# UNITED STATES PATENT AND TRADEMARK OFFICE

10/042,567

## Office Action Summary

***DETAILED ACTION***

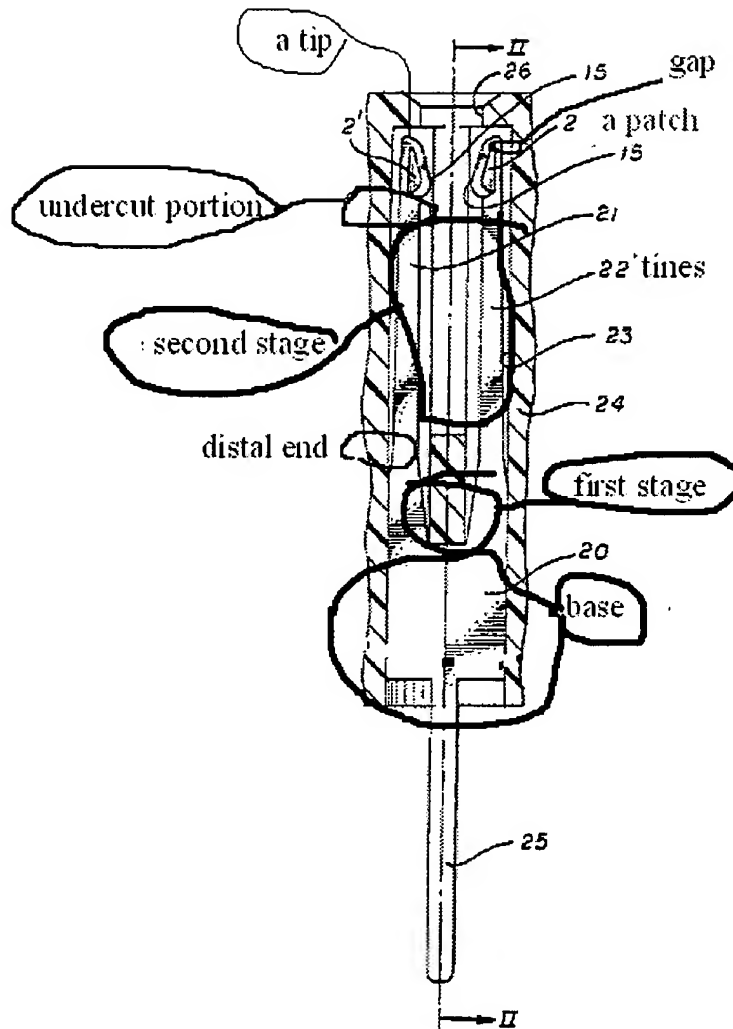
-- In reference to Claim(s) 3, Frommer shows (see examiner's figure)

providing at each of the plurality of tines 22 a first stage proximate a base that includes a first inner diameter and a second stage that is disposed intermediate between a tip and the first stage and where the second stage includes a second inner diameter at the one end thereof that is greater than the first inner diameter and wherein each of the plurality of tines includes a patch proximate ~~a~~ the tip, the patch having a thickness that is greater than an adjoining undercut portion.

-- In reference to Claim(s) 5, Frommer shows (see examiner's figure) each of the tines 22 includes a first stage and a second stage, the first stage having a first wall thickness that is thicker than a second wall thickness of the second stage that is disposed proximate to the first stage and which extends therefrom toward a tip of each tine.

-- In reference to Claim(s) 6, Frommer shows the means for receiving a pin in the socket includes providing an undercut portion (see examiner's figure) in each of the tines a predetermined distance from the tip.

-- In reference to Claim(s) 7, Frommer shows (see examiner's figure) the undercut portion extends to the first stage.

-- In reference to Claim(s) 8, Frommer shows (see examiner's figure) each of the tines includes a patch of material that is adapted to contact a pin, the patch being disposed intermediate the tip and the undercut portion.

-- In reference to Claim(s) 9, Frommer shows (see examiner's figure) the patch of material includes a greater thickness of material than the undercut portion.

-- In reference to Claim(s) 13, Frommer shows (see examiner's figure) a gap.

-- In reference to Claim(s) 14, Frommer shows (see examiner's figure) each of the plurality of tines have curved portions (at the patch shown in the examiner's figure)).

-- In reference to Claim(s) 15, Frommer shows (cover sheet) the socket 20 includes a hood 24 having a predetermined inside diameter that surrounds the plurality of tines, and wherein when a pin is mated inside of the socket, the plurality of tines extend radially outward a greater amount at the tip than at the distal end (see examiner's figure), and wherein a gap (see examiner's figure)
